# CITY OF ALBUQUERQUE

RE: **Lots 19Block 5 Volcano Cliffs Unit 22 SAD 228**  
**6620 Sujeto Rd. NW**  
**Grading and Drainage Plan**  
**Engineers Stamp Date; 9/10/2020 (D10D003K19)**  
**Pad Certification Date; 8/28/2021**  
**CO Certification Date; 9/30/2022**

Based on the Certification received 9/31/2022, this site cannot be accepted for release of Certificate of Occupancy by Hydrology until the following comments are addressed.

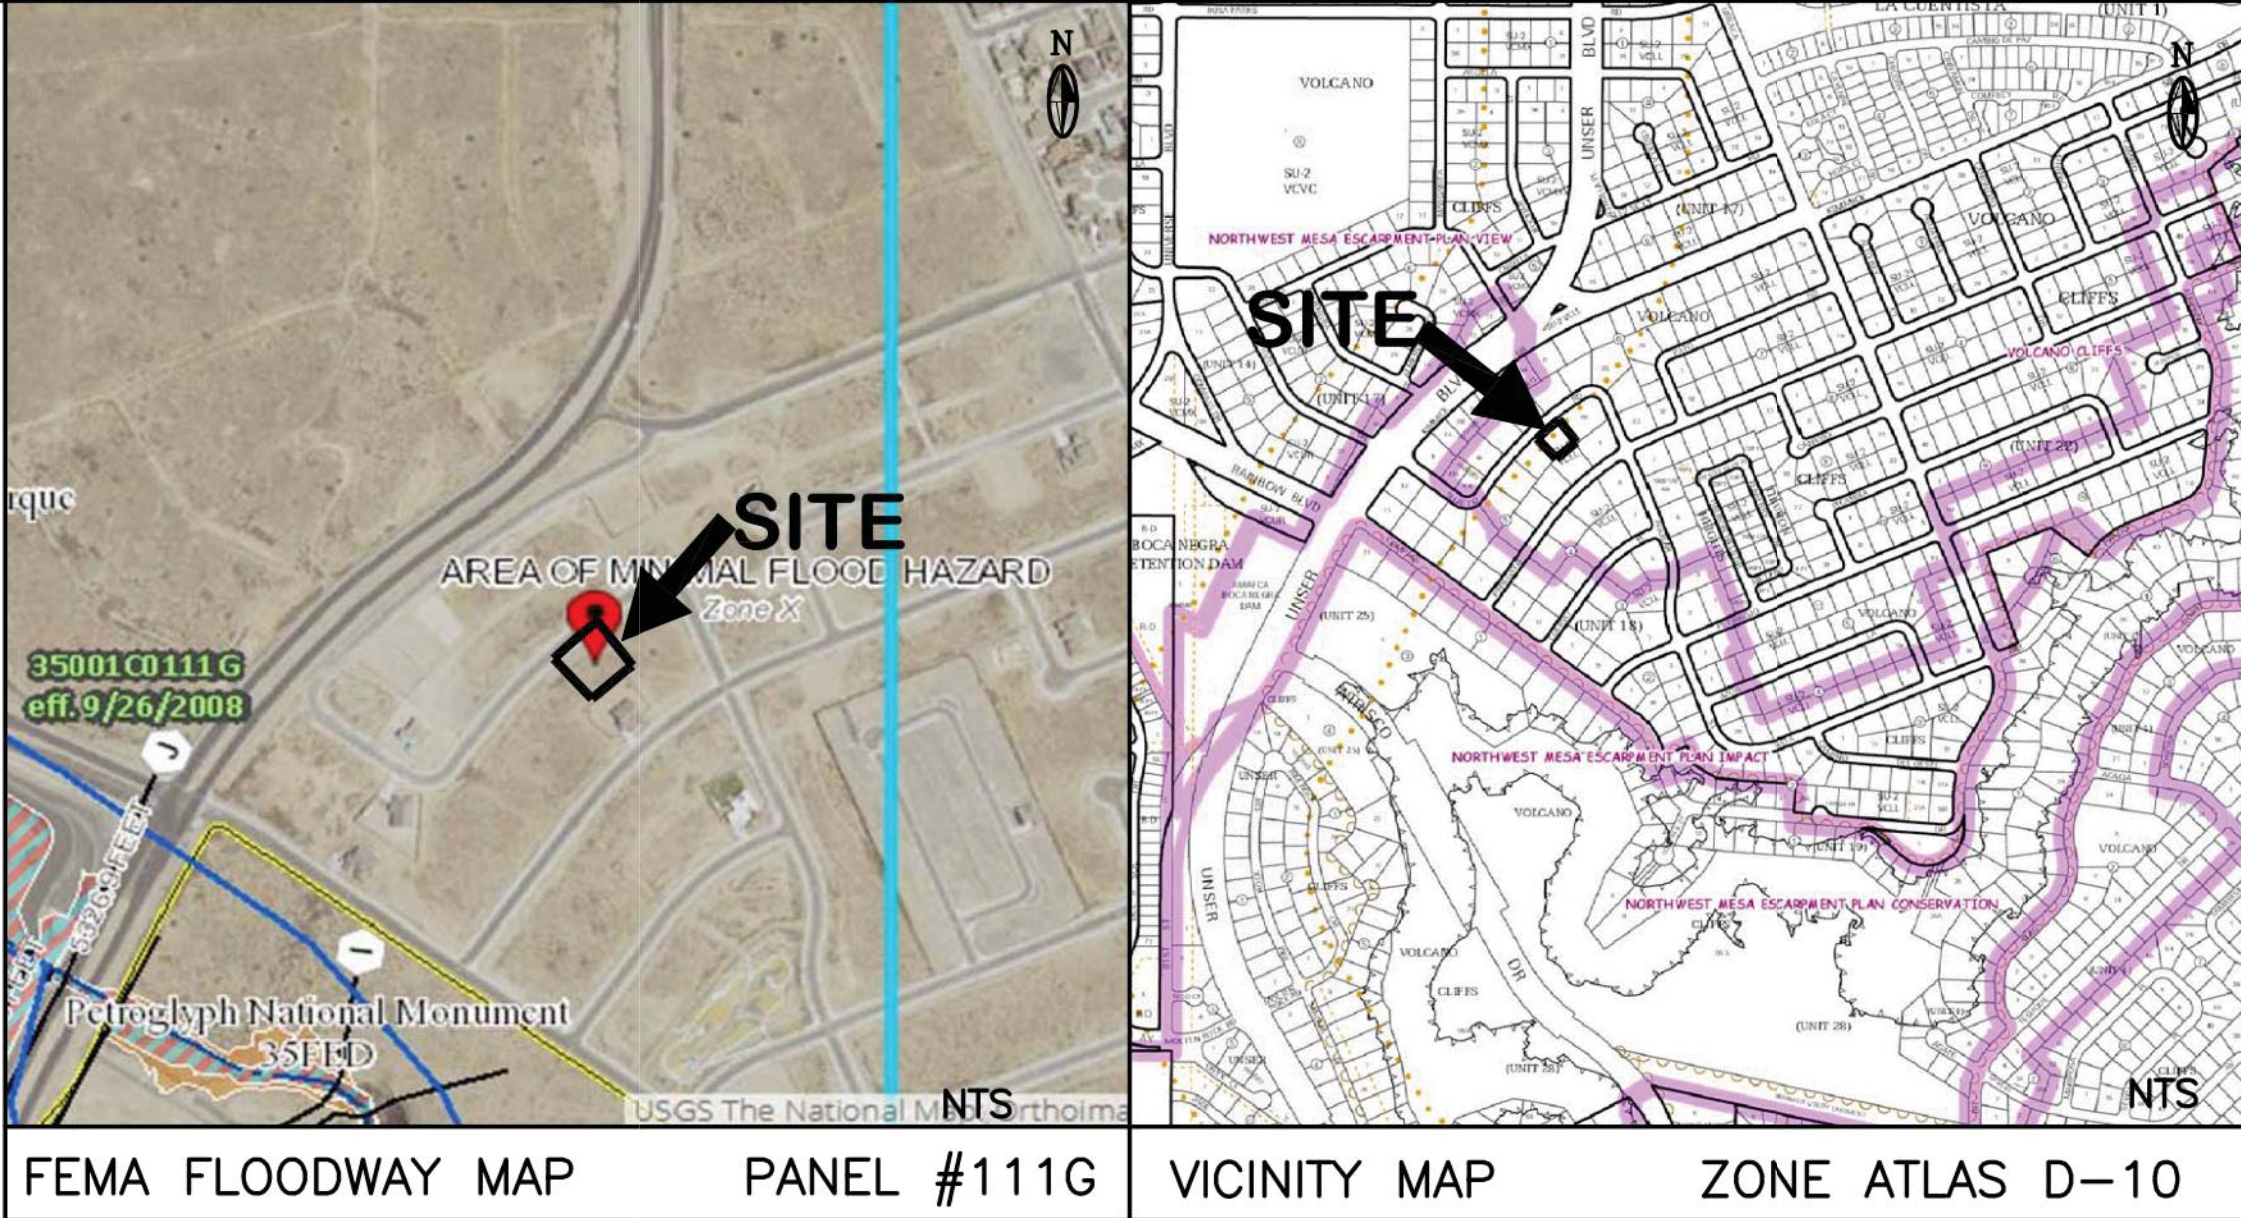
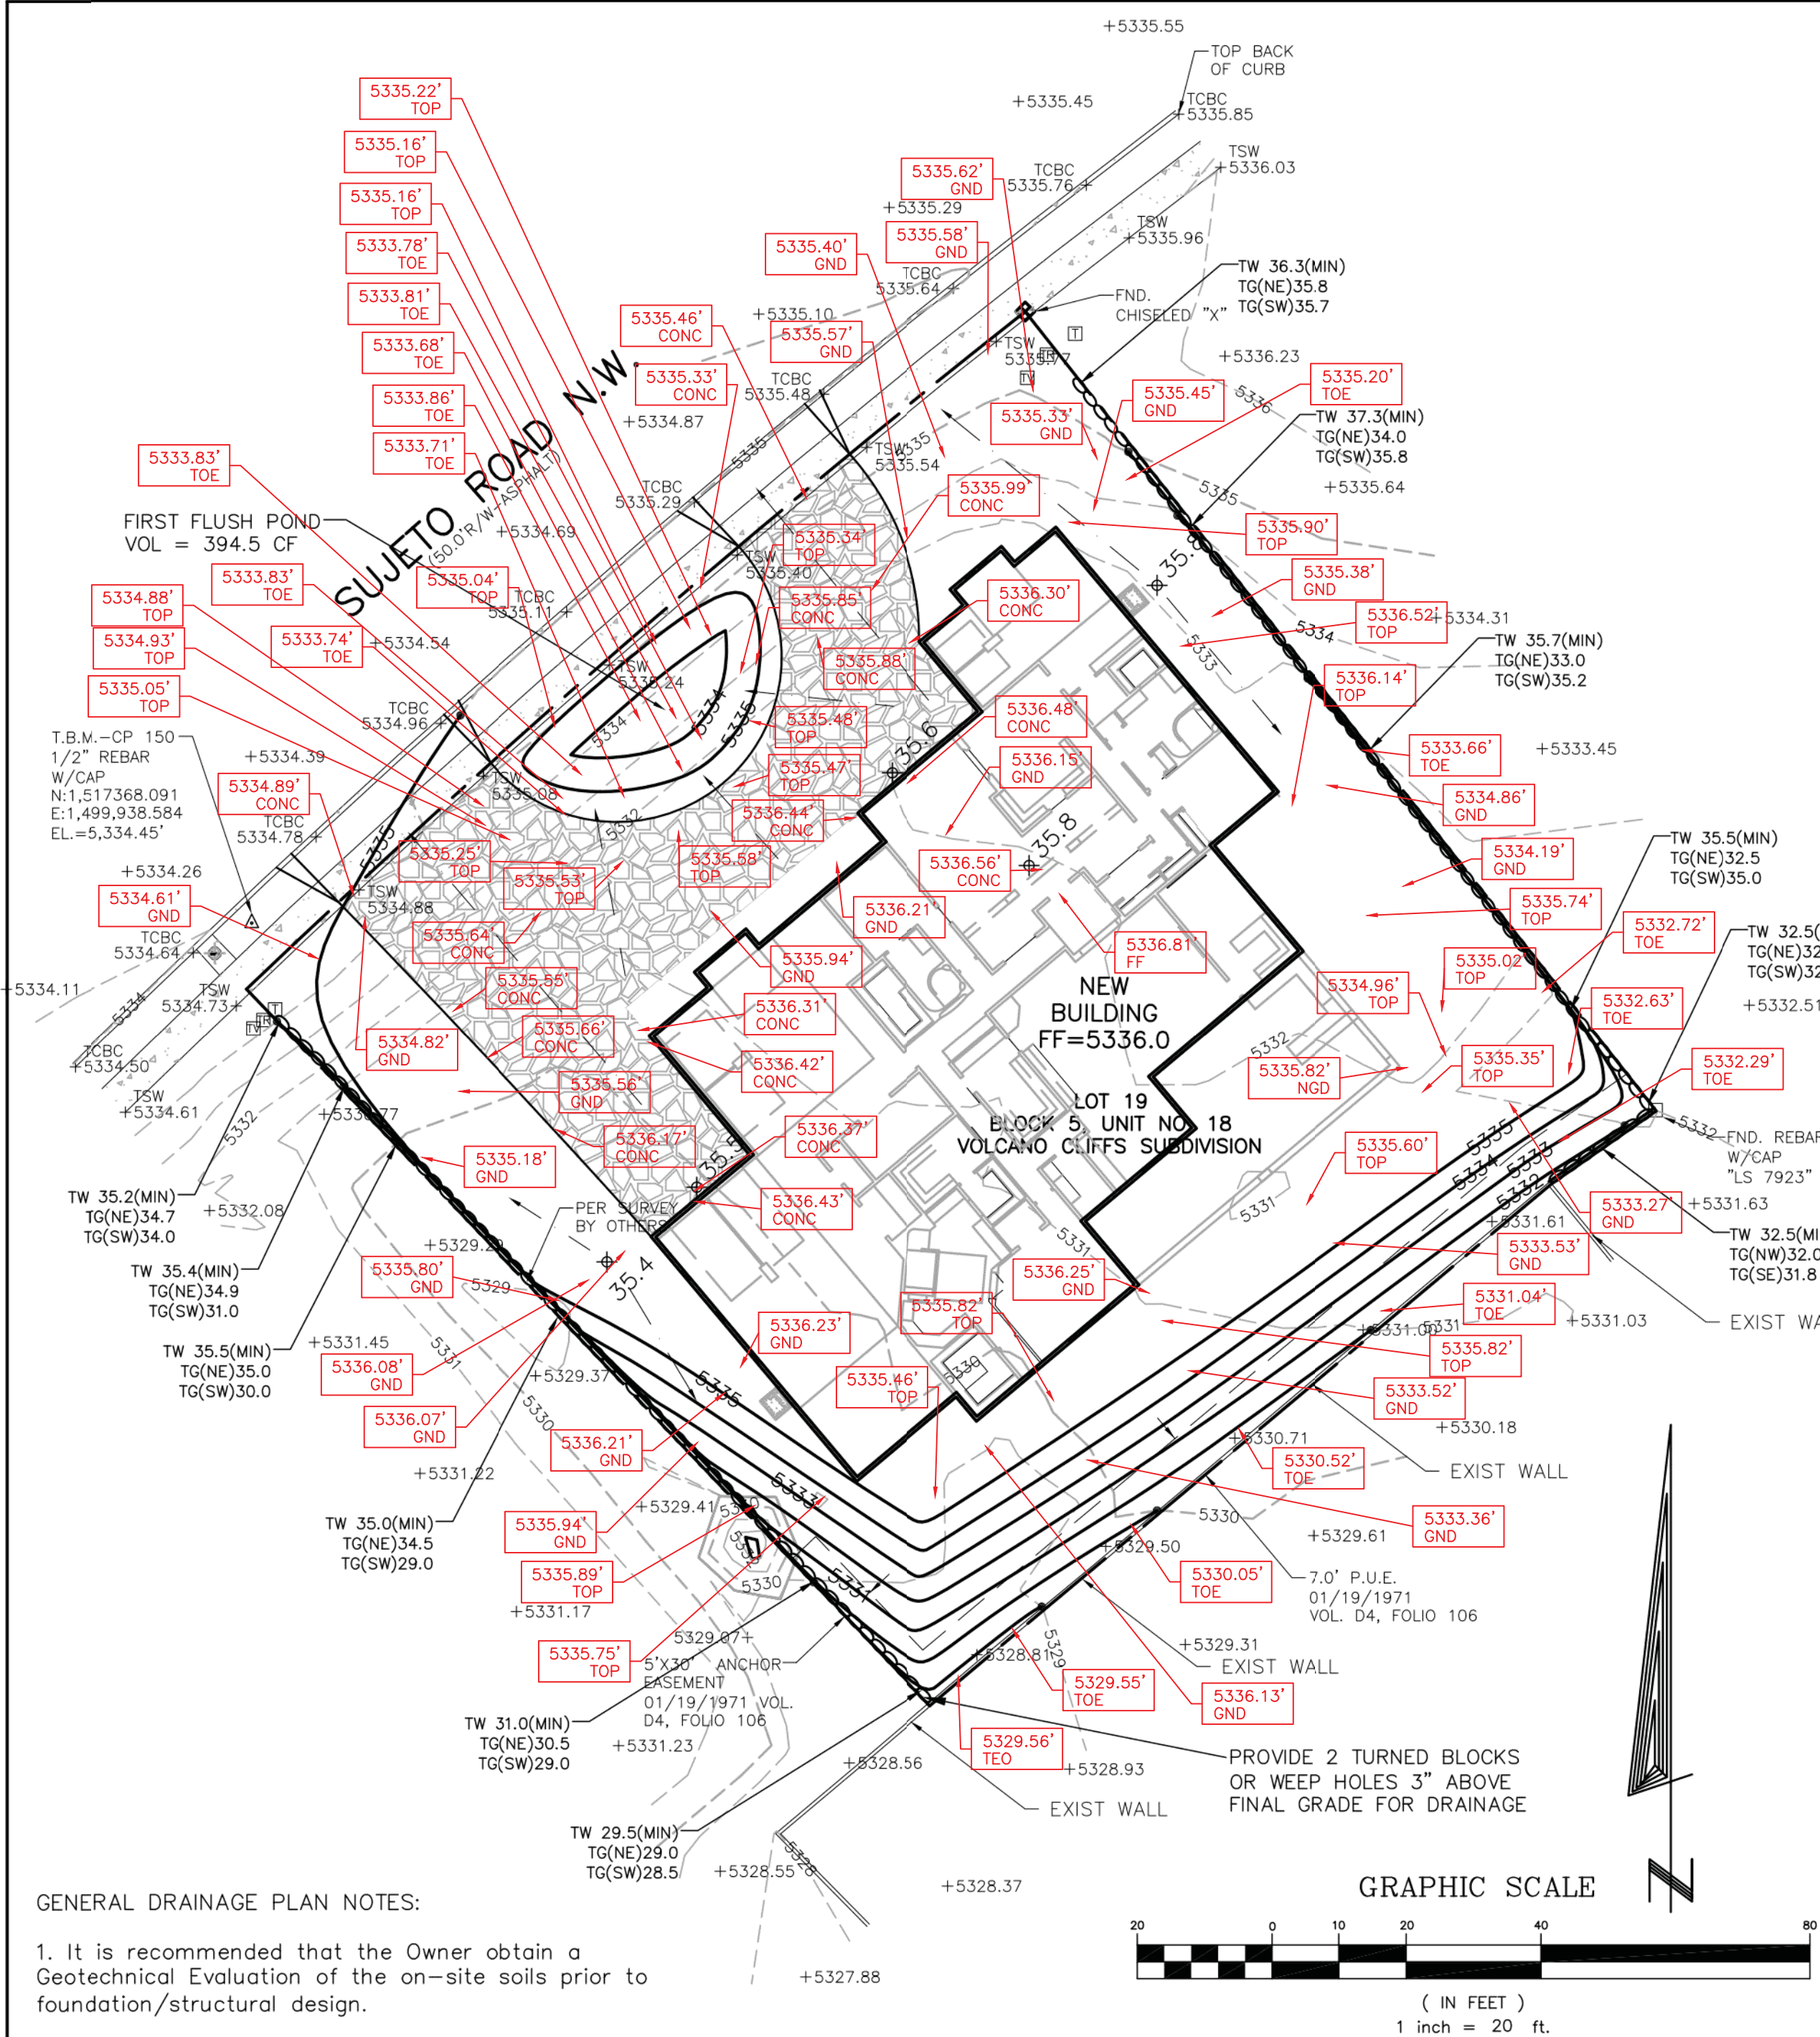
- The rear yard does not have erosion protection.
- Erosion protection needs to be placed against the east cmu wall, at least 2 feet high at a grade of 3:1.
- The cmu wall must be finished in the east yard or a pond placed in front of the opening with erosion protection.
